TENDER T-2025-42

Burgess 1 Dam Rehabilitation

ADDENDUM #3

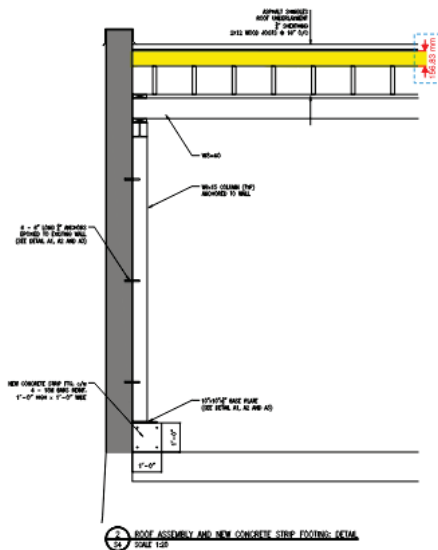
Q25. Dwg S1 and SP 10.1 provisional Support Exist Sanitary Sewer and SP10.2 provisional Support Exist Watermain. Given the depth of the proposed north retaining wall and proximity of the existing watermain & sanitary sewer, it likely isn't feasible to support the watermain & sanitary sewer during the excavation for the retaining wall. Can you please review and look at the possibility of introducing a tender item to isolate/remove/replace 15m of watermain (3 exist valves can isolate watermain) as well as 15m of sanitary sewer (sewer would require bypass pumping – please provide flows). If it is decided not to introduce these two pipe replacement items, can you please add a tender item to address sewage flow bypassing and provide flows?

A25. The municipal water and sanitary sewer systems are owned and operated by the District of Muskoka. Available as-recorded drawings are attached for information purposes. The District's standard supplementary specifications are attached to provide the requirements for bypass sewage pumping and temporary water supply systems. The Tenderer shall base their bid on providing both temporary systems whether they are required or not. The Contractor shall have these systems in place prior to any excavation for the retaining wall. Installation of replacement pipe shall be a provisional item based on metres of size-for-size, like-for-like replacement including District approved couplings that may be required as a result of the work. An additional addendum will be provided with appropriate items to cover the required temporary systems and provisional pipe replacement.

**ROOF ACCESS HATCH
DESIGN DETAILS**

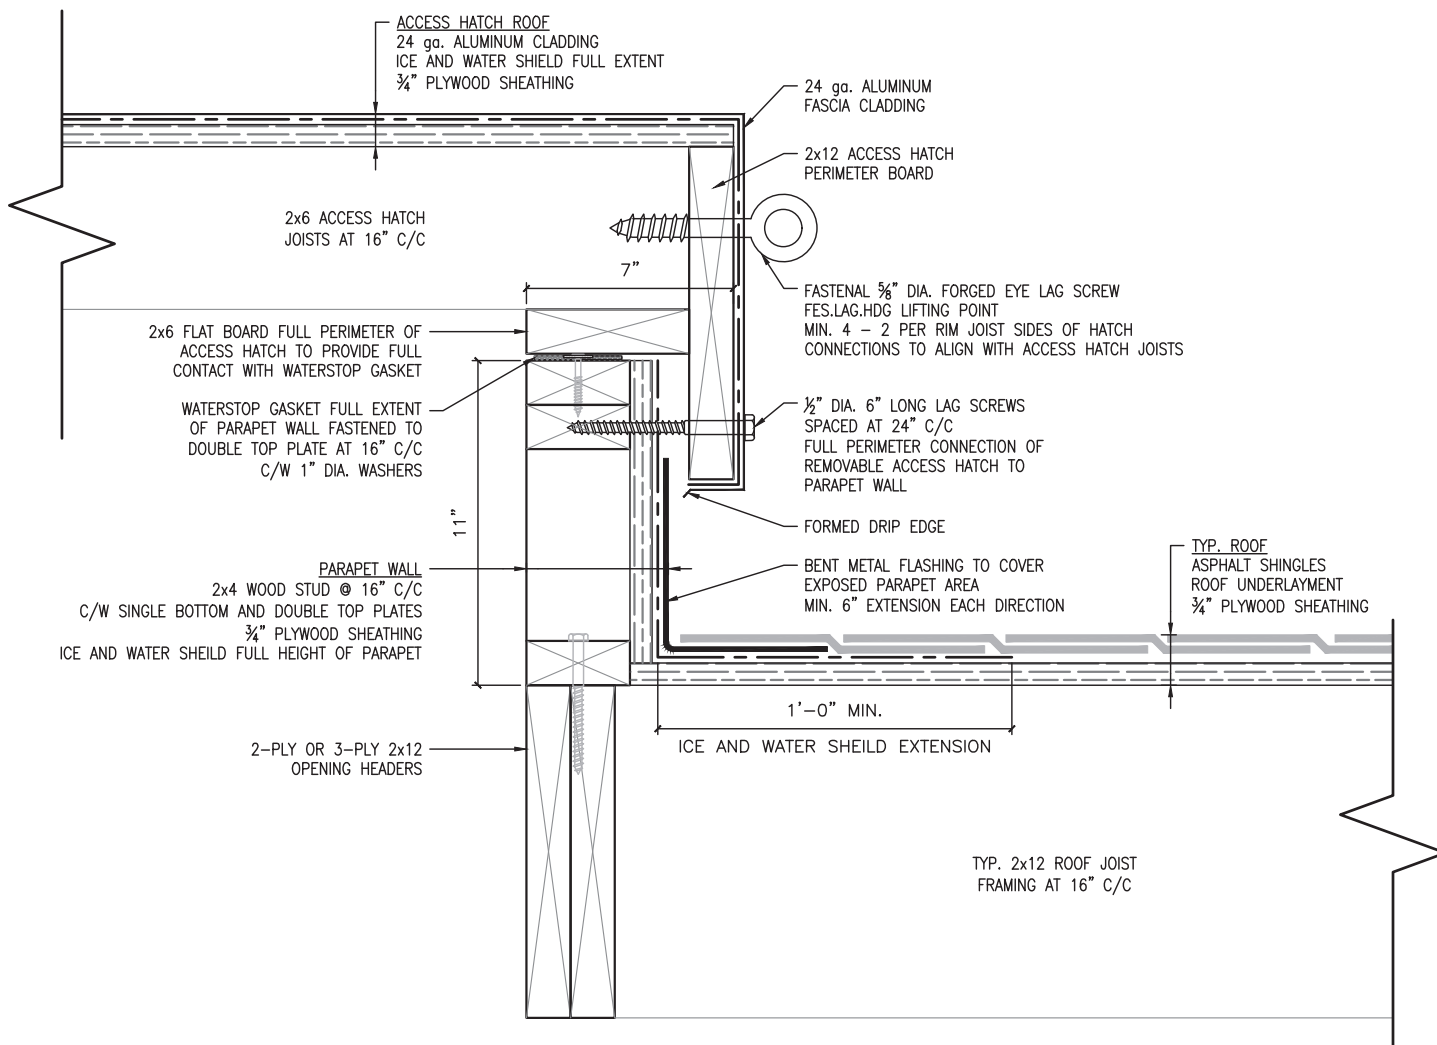
Q2. Would it be possible to provide more details regarding the removable hatches intended for equipment servicing or replacement? What material should they be made from and should they be insulated?

Q14. Please provide the specification of the 2 roof hatches 10' x 10' to be installed on the roof.

Q15. Please provide detail drawings and specifications of parapet farming, flashing around the removable 2 opening on the roof and lugs.

A2. See detail attached.

A14. See response for Q2 above.

A15. See response for Q2 above.
